APPLICATION NO.	FILING DATE	FIRST NAMED INVENTOR	ATTORNEY DOCKET NO.	CONFIRMATION NO.
10/814,478	03/31/2004	Mario Stigler	0275M-911/CO	7889
27572	7590	11/02/2004	EXAMINER	
HARNESS, DICKEY & PIERCE, P.L.C. P.O. BOX 828 BLOOMFIELD HILLS, MI 48303			WUJCIAK, ALFRED J	
			ART UNIT	PAPER NUMBER
			3632

Office Action Summary	Application No.	Applicant(s)	
	10/814,478	STIGLER, MARIO	
	Examiner	Art Unit	
	Alfred Joseph Wujciak III	3632

This is the first Office Action for the serial number 10/814,478, RETAINING CLIP WITH OFFSET LATCHING FINGERS, filed on 3/31/04.

(11)Publication number : 09-317946

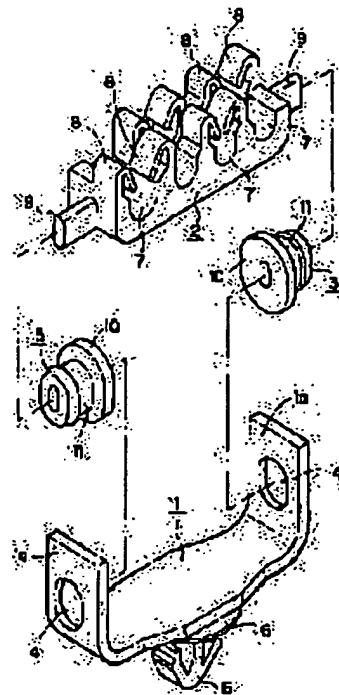
Tomoyoshi teaches a retaining clip (figure 1, page 6) having a base part (2) with receivers (7) and at least one partition (upright part of base part (2)). The partition comprises a front side and a rear side having at least one first latching finger (8) at the front side and at least one second latching finger (8) at the rear side of the partition. The width of each latching finger is smaller than the width of the partition. The first latching finger is arranged offset relative to the second latching finger (figure 1). The partition is elbowed (a wall located underneath latching finger and adjacent to curve part of element 7) between the offset latching fingers. The partition has an opening in the form a slot (figure 2, b, page 5). The clip comprises outer walls (located on both end of clip and adjacent to element 9) having at least one latching finger (8). The outer walls are reinforced by reinforcing structures (9-10).
